City of Portland, Maine - Building or Use Permit Application 389 Congress Street, 04101, Tel: (207) 874-8703, FAX: 874-8716 Permit No: Owner: Location of Construction: Phone: Martha Sichrest 842-0162 04102 118 Tucker Ave. Owner Address: Lessee/Buyer's Name: Phone: BusinessName: Woodworth Ave. 04103 Permit Issued: Phone: Contractor Name: Address: On the second second COST OF WORK: PERMIT FEE: Past Use: Proposed Use: \$ 30.00 \$ 500,00 Single Family Same **FIRE DEPT.** □ Approved INSPECTION: Use Group 1/3 Typ 5 1/3 □ Denied CBL: Zone: BOCA96-1 Signature: Zoning Approval: Proposed Project Description: PEDESTRIAN ACTIVITIES DISTRICT (P. Action: Approved Special Zone or Reviews: Approved with Conditions: ☐ Shoreland Erect 6'x14' PressurgeTreated Deck Denied □ Wetland ☐ Flood Zone ☐ Subdivision Signature: Date: ☐ Site Plan maj ☐minor ☐mm ☐ Permit Taken By: Date Applied For: (ii) October 12,1999 **Zoning Appeal** □ Variance This permit application does not preclude the Applicant(s) from meeting applicable State and Federal rules. ☐ Miscellaneous 2. Building permits do not include plumbing, septic or electrical work. ☐ Conditional Use ☐ Interpretation 3. Building permits are void if work i

PAGE 02 LOT 4 TUCKER WOODS

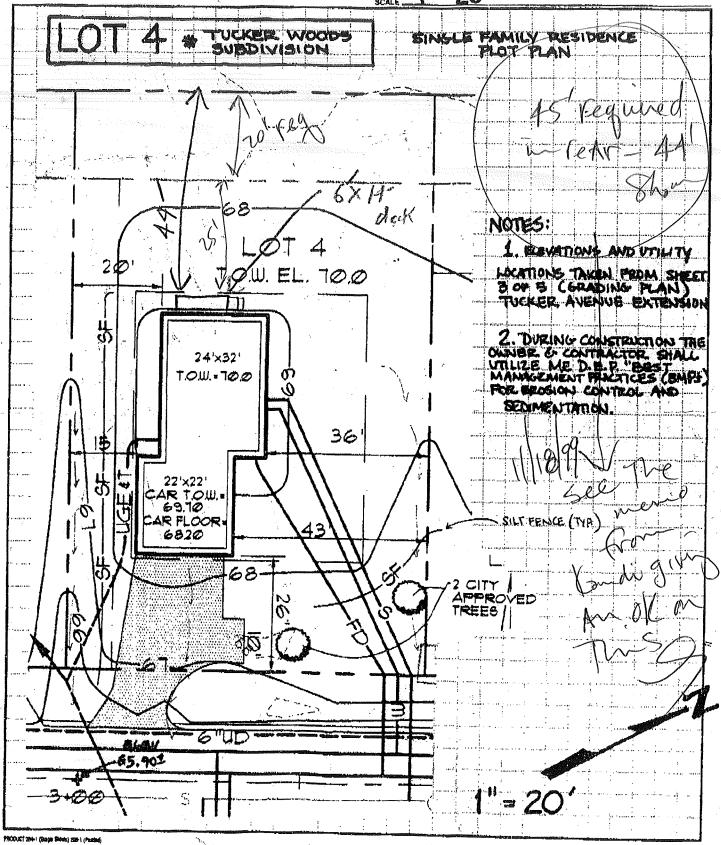
attached to The dwelling Shall be Lagged sono Tube shall be placed on a Footing

6 × 14 - one sect of stairs gee report

2×8 pT floor joist,

S/4×6 pT dection

4×9 posts - 2×9 rail system V

4° spendle special.

10×7 when and rise V

10" Some tibes
